Applicant: Brian Vlach, Three Rivers Park District (TRPD)
Applicant's Contact: Dan Mossing, Emmons & Oliver Resources (EOR)
Project: Bryant Lake Culvert Replacement
Location: 6800 Rowland Rd, Eden Prairie
Rule(s): 3, 5, and 6
Reviewer(s): Louise Heffernan and Bob Obermeyer; Barr Engineering

BRYANT LAKE CULVERT REPLACEMENT
 EDEN PRAIRIE, HENNEPIN COUNTY,
 MINNESOTA
 STATE PROJECT NO. --- CITY PROJECT NO. ---

SITE PLAN
 SHEET 05 OF 09 SHEETS

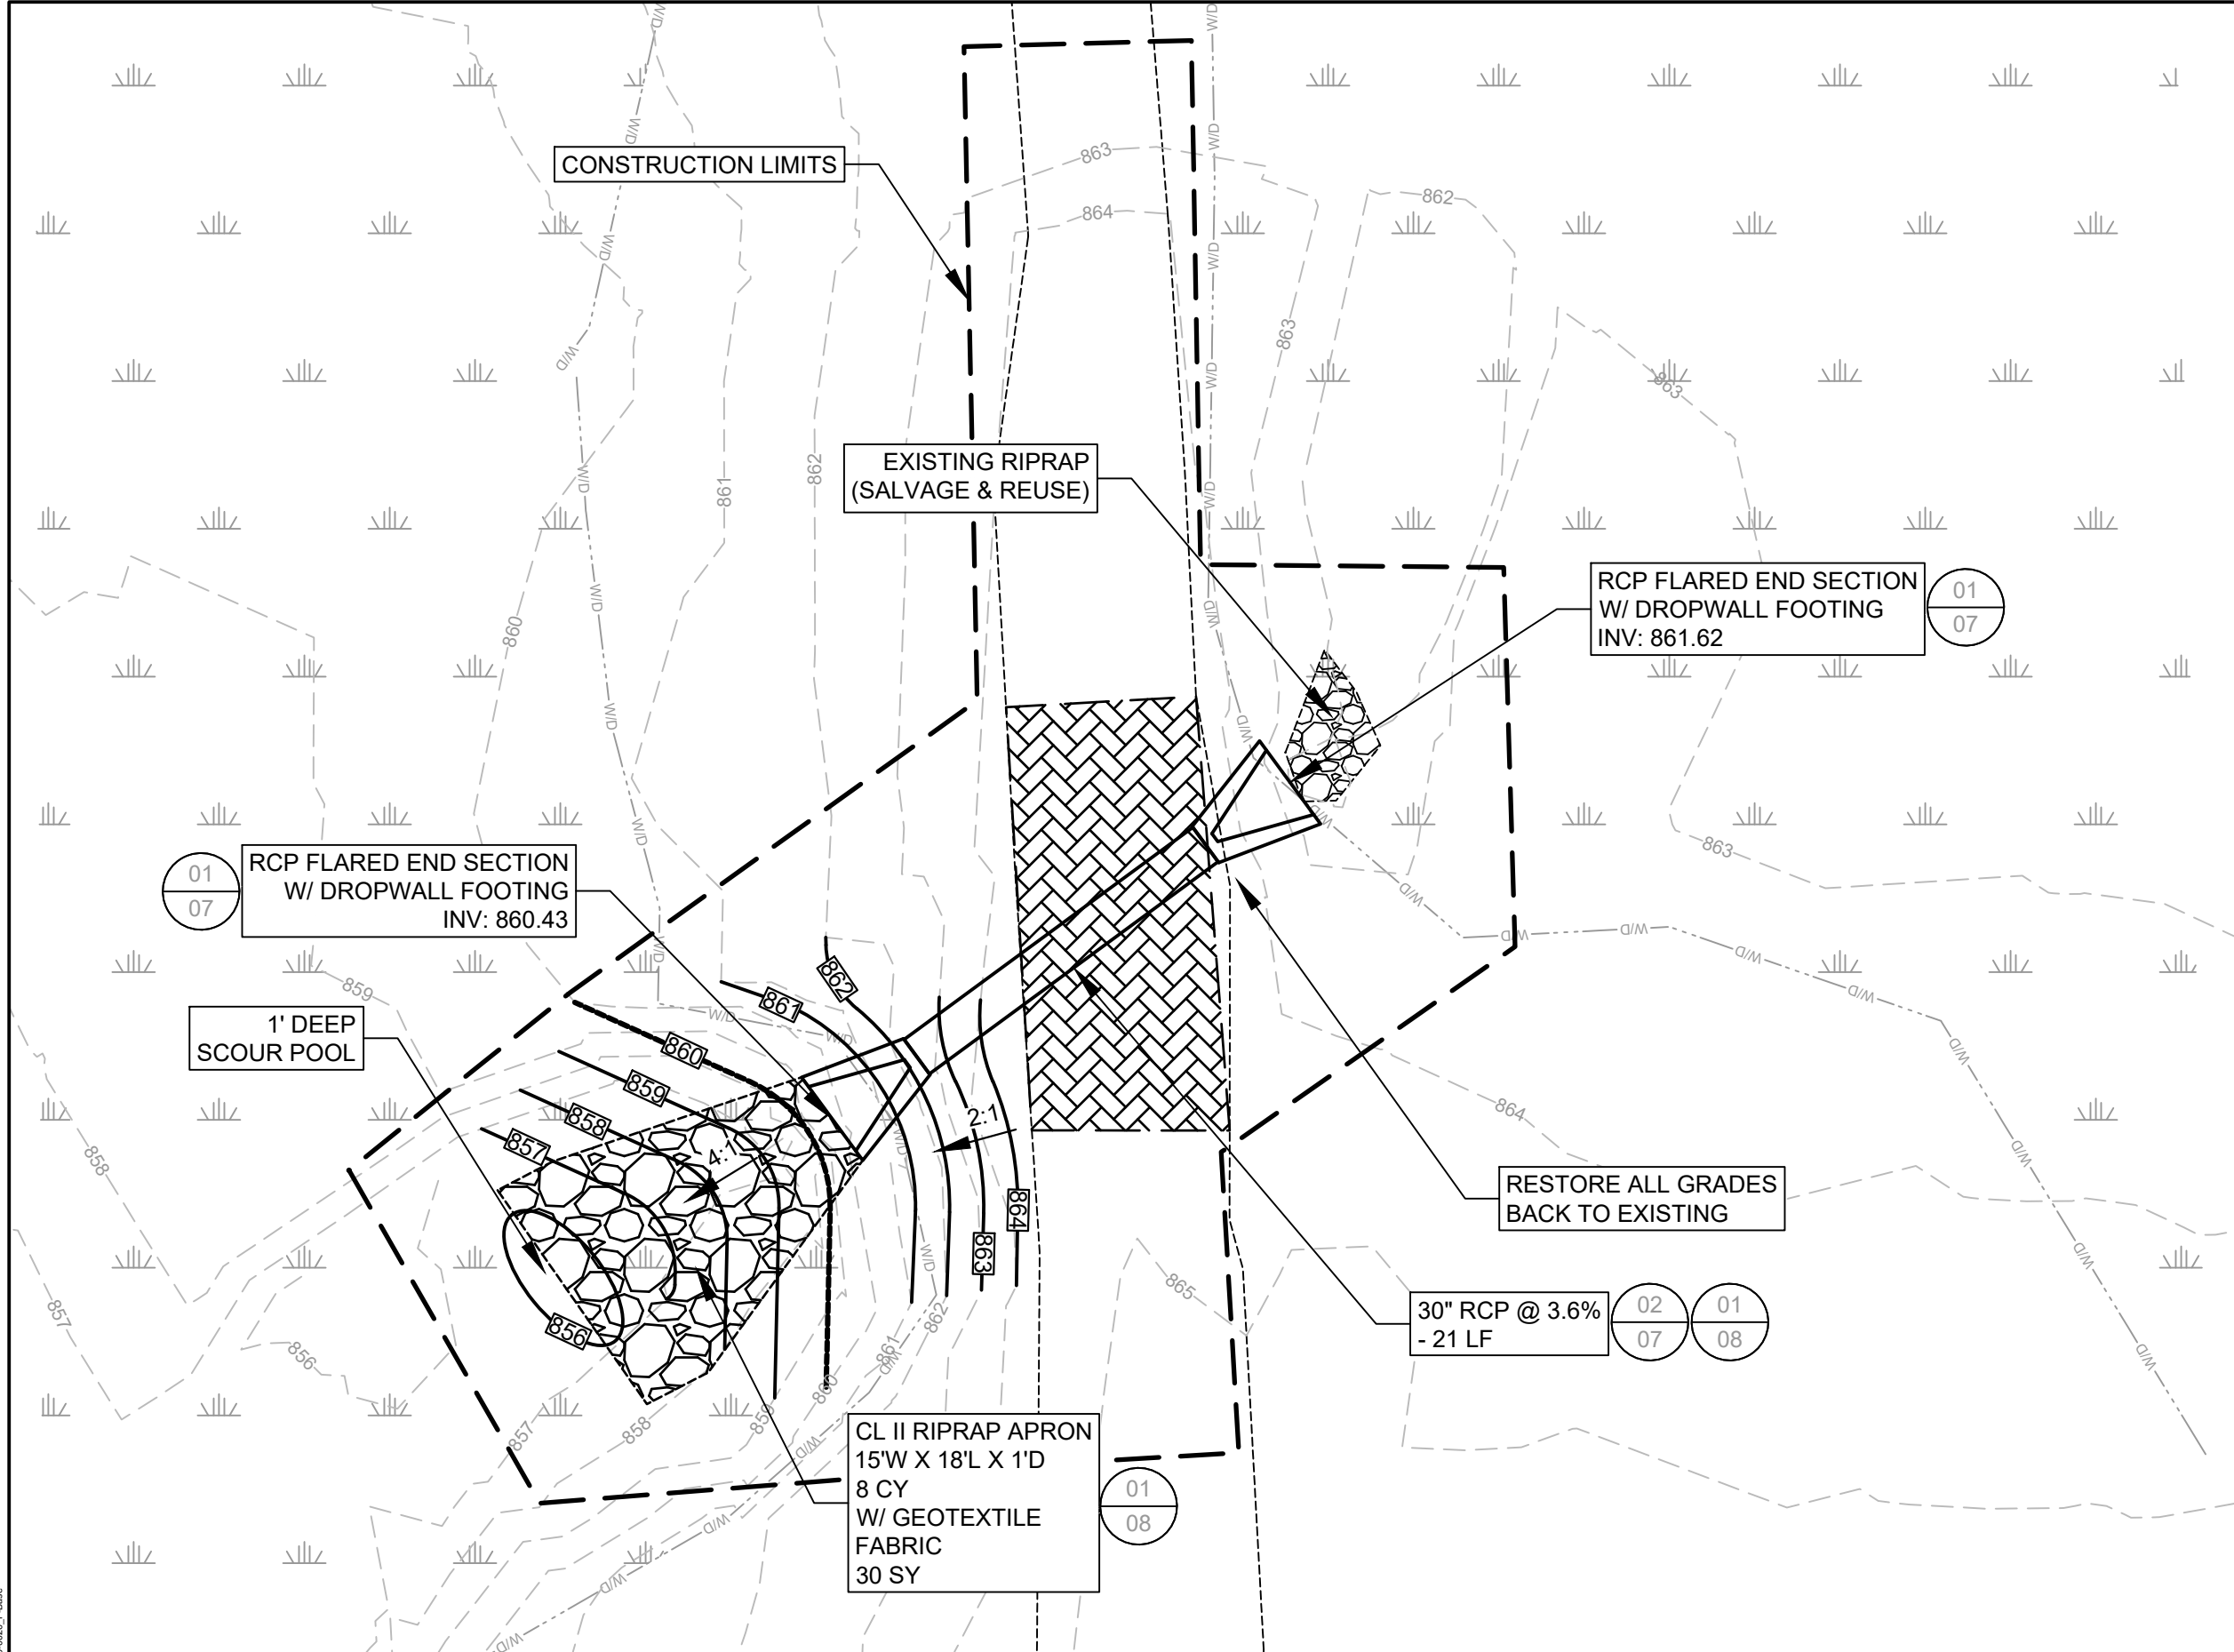
The proposed storm sewer improvements, including installation of flared end sections with the riprap, will provide stabilization and minimize erosion and scour from occurring at the pipe outfalls.

Erosion control measures including silt fence and bioroll check dams will be installed to minimize water quality impacts (sedimentation) during construction. Disturbed areas will be stabilized with erosion control blanket and native seeds.

The wetland in contact with the downstream end of the culvert proposed to be replaced was identified as a potential hydrologic restoration opportunity as part of the district's recent Wetland Restoration and Protection Opportunity Identification project. The district plans to prioritize hydrologic restoration opportunities based on initial identification of willing landownership partners and prioritization of desirable functional goals for each area in the study following further evaluation. Should improvements, repairs or modifications within this area be proposed, the district would be interested in evaluating this area and partnering with Three Rivers Park District for hydraulically restoring the wetland.

Approval contingent upon the following:

The applicant providing a name and contact information from the contractor responsible for the erosion and sediment control at the site. NMCWD must be notified if the responsible individual changes during the permit term.

Per Rule 6.5, the City must submit for NMCWD approval, then execute an agreement providing for the maintenance of the crossing replaced by the project
